PENNSYLVANIA POWER & LIGHT COMPANY
SUSQUEHANNA STEAM ELECTRIC STATION
OFFSITE DOSE CALCULATION MANUAL

SUMMARY OF ODCM CHANGES

This revision documents changes to sampling stations pursuant to SSES Technical Specifications 3.12.1.c and 3.12.2.b. Henceforth with this revision, all changed pages will be indicated by an approval/date box rather than date stamp.

FIGURE 6

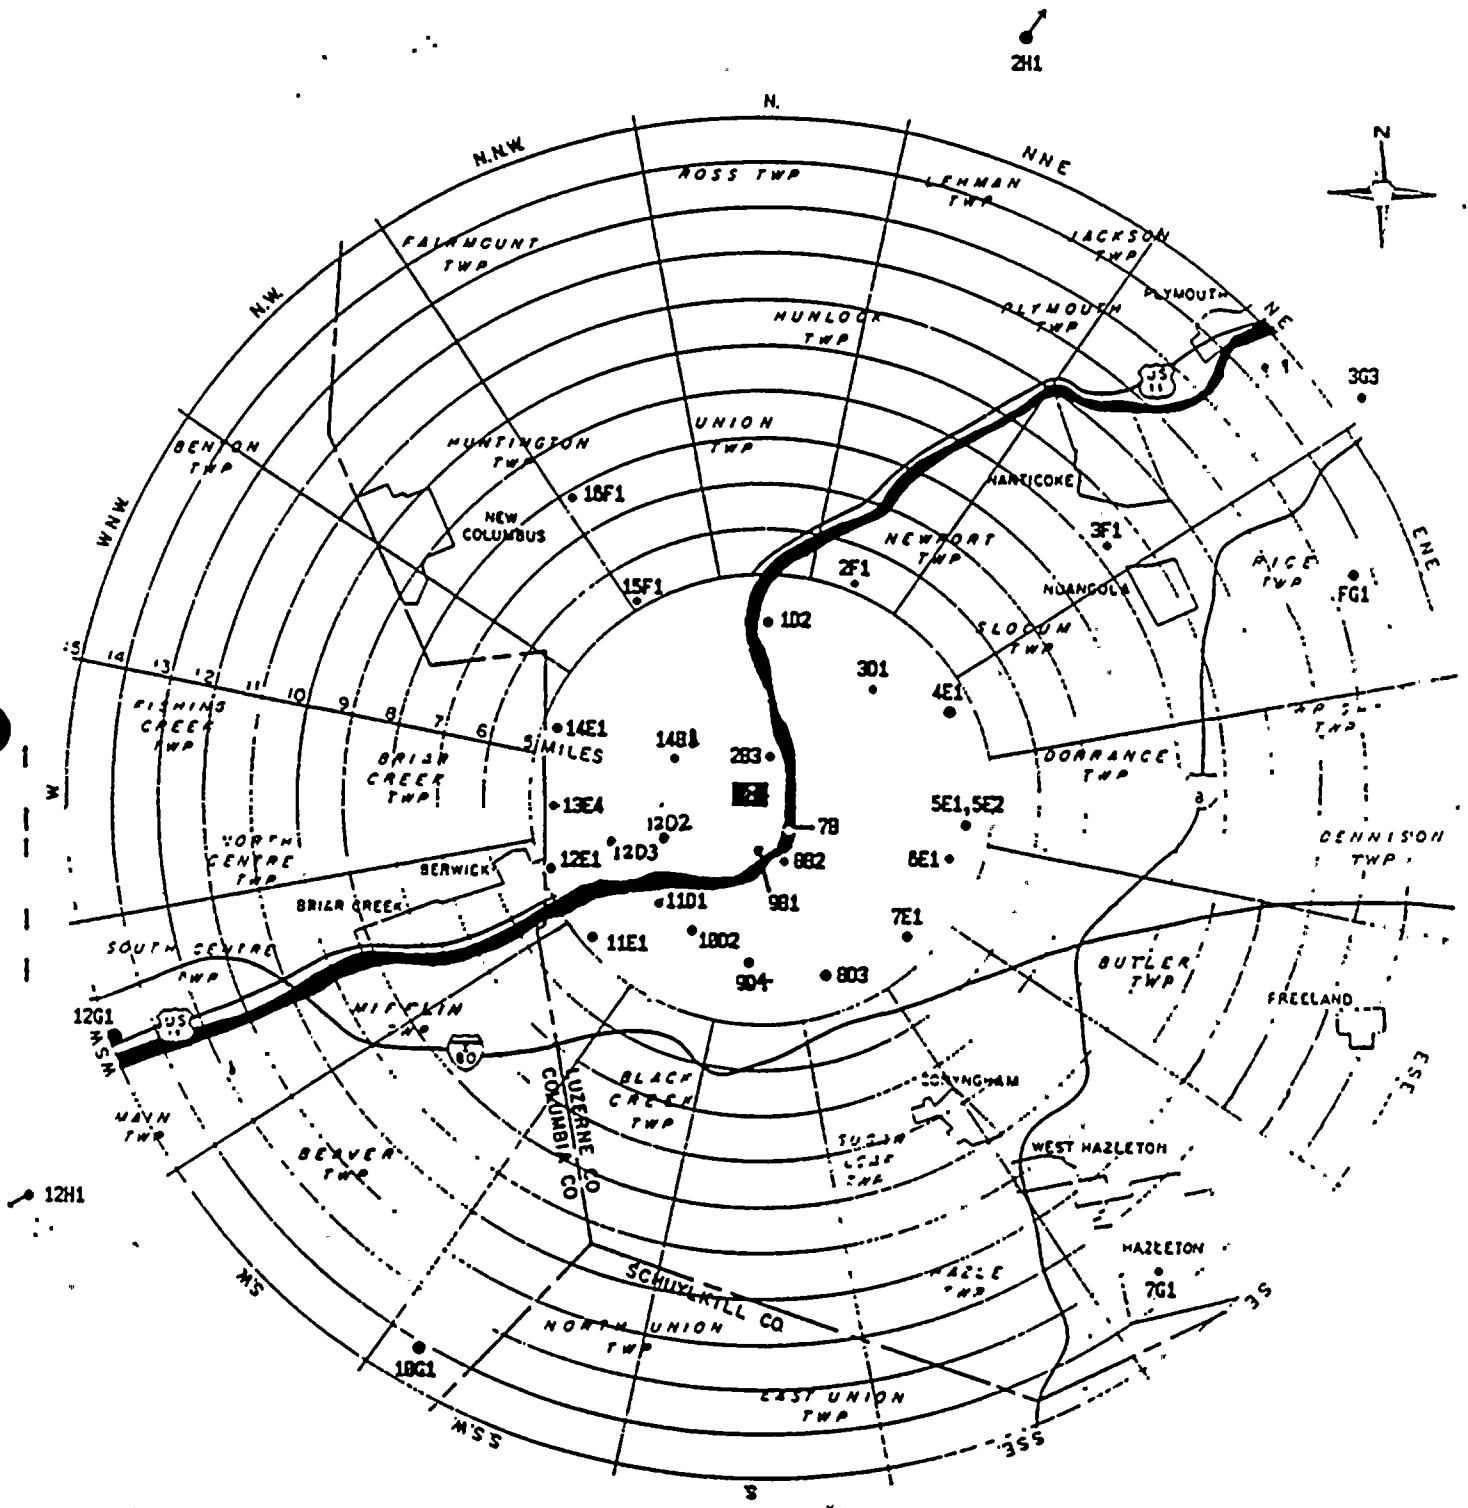
1. Sampling stations 12S2 and 3S2 replace stations 11S2 and 2S2, respectively.
2. TLD station 9D4 replaces station 9D1; the only change of actual locations. Other locations (2B3, 9D4, 4E1, 10D2, and 11E1) have name changes.
3. Milk station 12B2 has been replaced by station 10D3.
4. Milk station 8D4 has been replaced by station 10D4.
5. Milk stations 13E3 and 9D3 were discontinued. Station 13E3 was replaced by 6C1, and 9D3 was not replaced due to low D/Q reported for this location.
6. Semi-monthly sampling frequency was reduced for station 10D1, due to low dose potential.
7. Milk stations 12B3 and 12D2 were added, due to their relatively high dose potential. Stations 12B3, 14B1 and 12D2 are now sampled semi-monthly per Technical Specification Table 3.12.1-1.
